Fern Bay Seaside Village Project Application

Further Response to Submission Report

Date:	7 April, 2010
Partner:	 Paul Douglass

Aspen Group

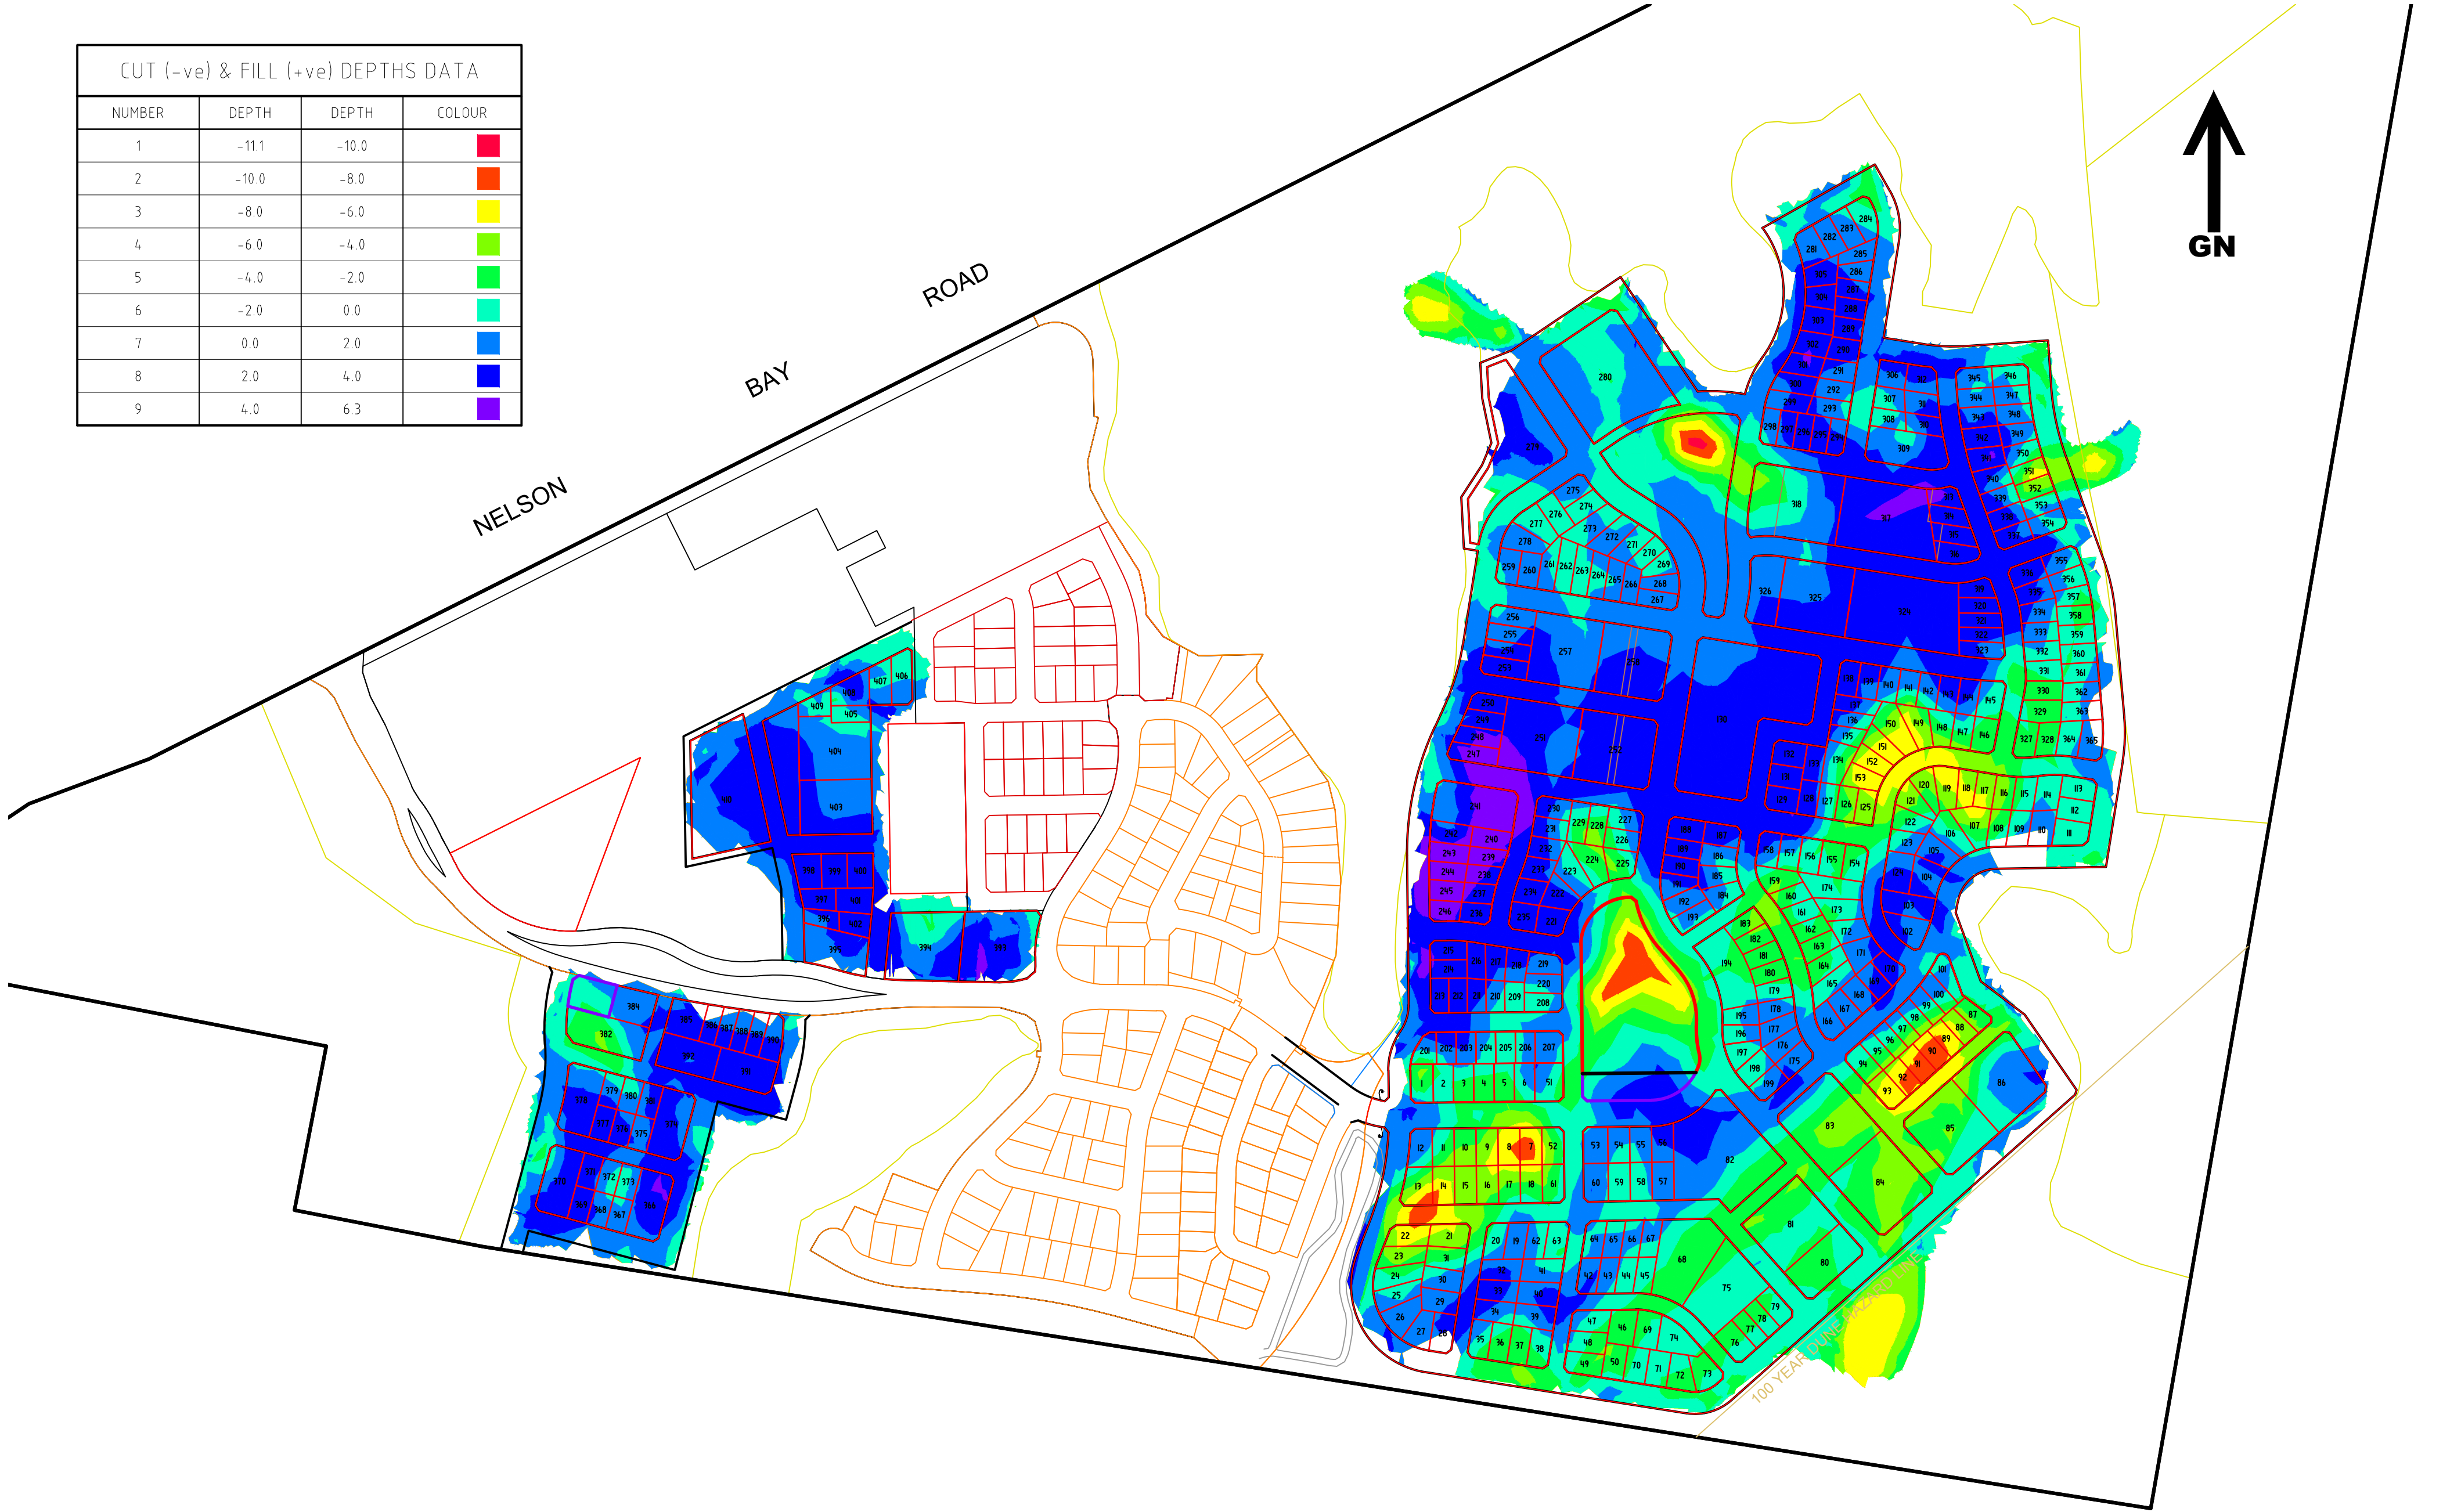
Cut and Fill	21	Reference is made to plan 22 of 22 (prepared by Daly Smith Pty Ltd, dated 22/12/2009) provided in the Submission Report in accordance with DoP's request. This plan depicts cuts of up to 6m and fill of up to 4 m occurring within the community Conservation Lands. DECCW advises that all cut and fill should be contained within the development area due to the potential impacts upon retained vegetation, particularly Swamp Sclerophyll vegetation.	Plan 22 of 22 has been amended and cut and fill outside the development footprint has been largely restricted to those required for construction of water management infrastructure.

The Preferred Project Plan application, including infiltration basins as outlined in amended plan set 29850 A, Sheet 22 of 22 in *Annex B*, delivers greater connectivity in terms of this wildlife corridor over what is envisioned in the Port Stephens Local Environment Plan 2000 (LEP 2000) where a large portion of the corridor between the bare dunes of Stockton Bight and Nelson Bay Road are zoned for Residential 2(a) and therefore urban development is permitted with consent.

(c) Drawdown between existing (model M1) and developed (model M7) conditions using basin recharge benchmarked using MUSIC modelling inflow volume estimates.

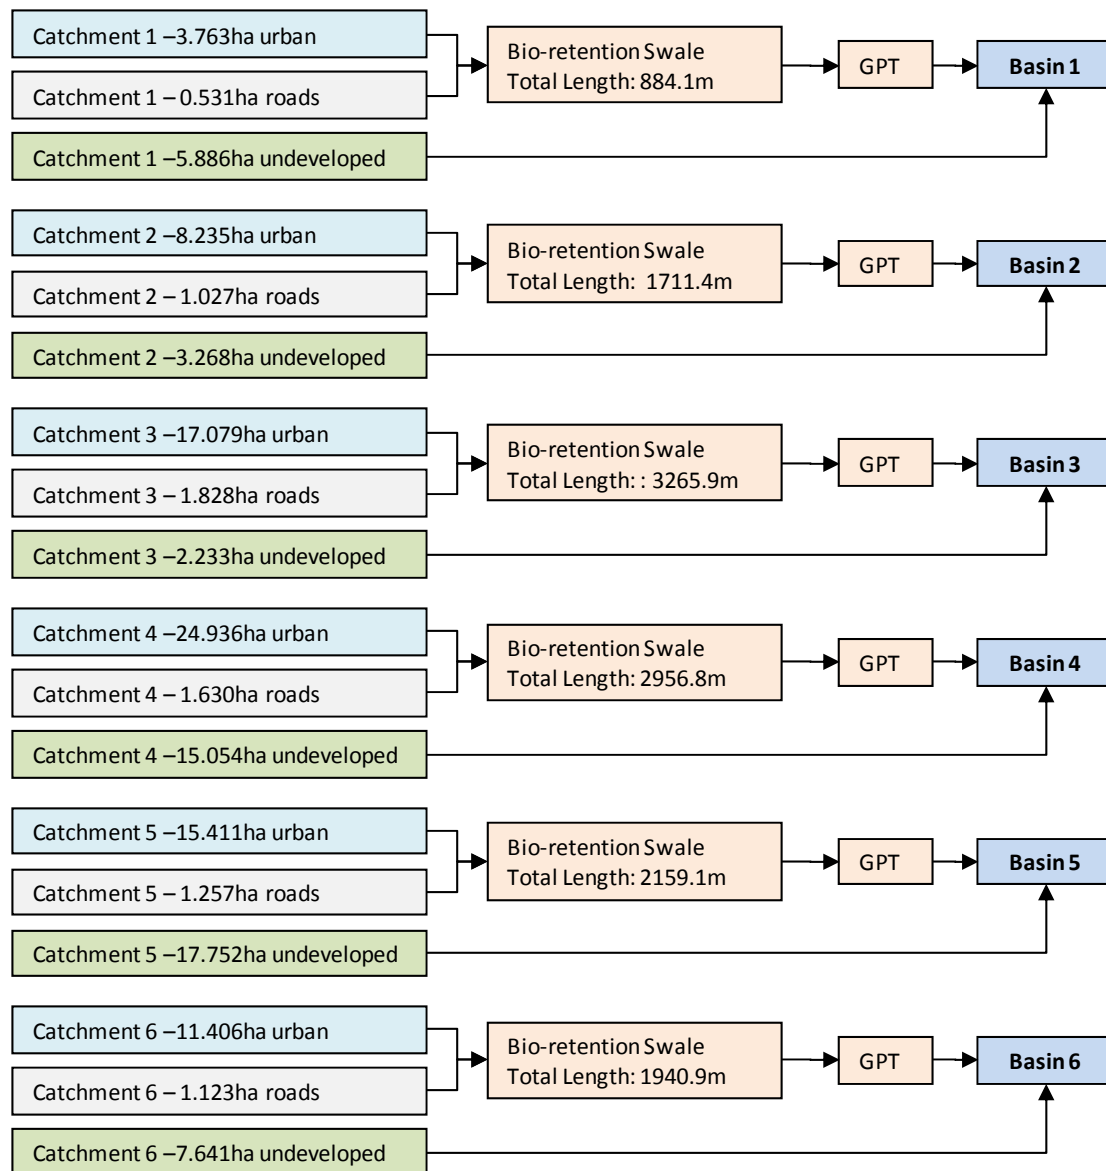
Prepare MODFLOW model runs based on recharge rates (for the developed conditions) which are benchmarked using information from the MUSIC model. This will provide a sensitivity analysis of the data provided in the original amended water cycle management strategy report.

Results of the modelling are provided in Figure 1 which shows drawdown plots (ie. difference between developed and existing conditions) under each recharge assumption. Figure 1a is the same as Figure 15 provided in the amended water cycle management strategy. Figure 1b shows drawdown (ie. difference between model M7 and M1) using the MUSIC model basin inflow volume estimates as benchmarks for groundwater recharge.

3. Using the MUSIC model to benchmark basin infiltration rates, results indicate that water tables may be raised in the order of 2-10 cm within the site and in the order of 2-4 cm at the site boundary in response to the urban footprint and increased recharge at the basins. We consider that this would be a 'worst case' estimate.
